COLUMBIANA HI TECH LLC

Re: RAI dated 12/22/05 for Revision 7 of the CHT-OP-TU, Certificate of Compliance No. 9288 / Docket Number 71-9288 and TAC Number L23884.

**Attachment B
Itemized RAI Response**

ATTACHMENT C – Explanation of Changes

Figure B-1 Effect of Carbon Content on Nil-Ductility Temperature^a

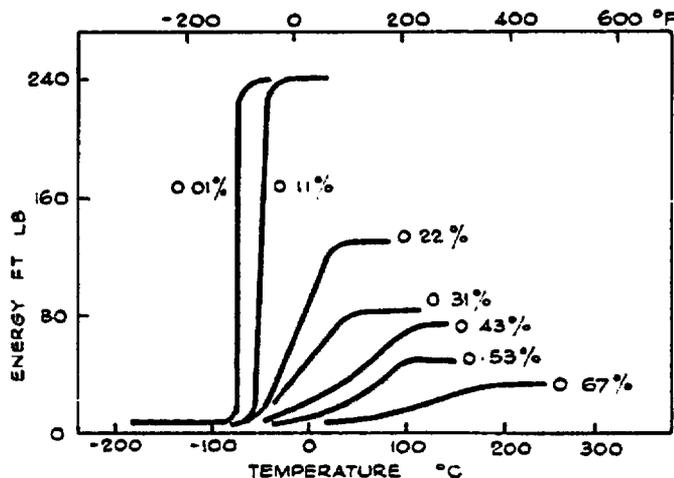
Question 1-6: Referring to the applicants RAI response dated January 6, 2004, Attachment A, page 3 of 12, justify and clarify the meaning of the statement, "the A53 grade B material performs better or the same as the rolled A569 used for the test..." Provide data or arguments to support the position taken.

Going from 0.02% to 0.30% carbon is shown in Figure B-1 to raise the transition temperature approximately 70°F. However, the addition of the manganese from 0.60 to 1.20% decreases the transition temperature by
